Project	IEEE 802.16 Broadband Wireless Access Working Group < http://ieee802.org/16 >	
Title	WirelessMAN-SCa PHY Extensions for Mobility	
Date Submitted	2003-05-08	
Source(s)	<p>Brian Eidson Conexant Systems, Inc. 9868 Scranton Rd, Suite 1000 San Diego, CA 92122-1791</p> <p>Russell McKown MacPHY Modems, Inc. 1104 Pittsburg Landing Richardson, TX 75080</p>	<p>Voice: (858) 713-4720 Fax: 858-713-3555 mailto: brian.eidson@conexant.com</p> <p>Voice: (214) 892-8903 Fax: (972) 671-1445 mailto: russell@macphymodems.com</p>
Re:	Response to 4/14/2003 call for contributions on 802.16e Task Group Review of document 802.16e-03/07r1.	
Abstract	Provides WirelessMAN-SCa PHY extensions and burst profile elements intended to enhance mobile operation while maintaining compatibility with 802.16a	
Purpose	To provide normative text on extensions that may be incorporated into the next update of the 802.16e-03/07r1 draft document.

WirelessMAN-SCa PHY Extensions for Mobility

Figure 1—Spread BPSK processing

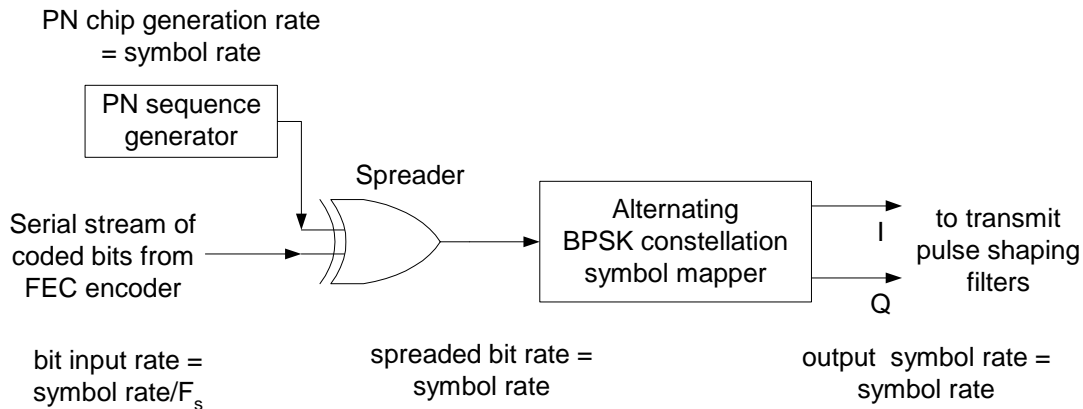
Figure 1 illustrates the generation of spread BPSK-modulated data with a spreading factor of F_s . Each input bit shall be held for F_s symbol clocks as it is XORed with F_s consecutive outputs of a PN sequence generator operating at the symbol rate. The XOR output shall feed a symbol mapper that alternates mapping assignments between two orthogonal BPSK constellations. These constellations are illustrated in Figure 2. BPSK MAP0 shall be used for even-indexed symbols, while BPSK MAP1 shall be used for odd-indexed bits. The first symbol to be mapped in a spread BPSK allocation shall be considered even.

Figure 3—Spreading PN sequence generator

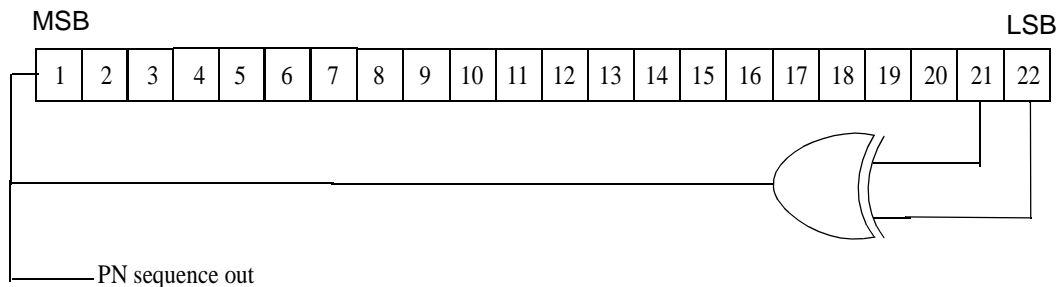
The spreading PN sequence generator shall be constructed from the Linear Feedback Shift Register (LFSR) illustrated in Figure 3. The characteristic polynomial for this LFSR is $1 + X^{21} + X^{22}$.

The PN sequence generator shall be preset at the beginning of a spread BPSK burst with one of the seeds listed in Table 1. Seed 0 is the default setting. Selection of any seed other than Seed 0 requires use of the burst profile encoding for spreading parameters.
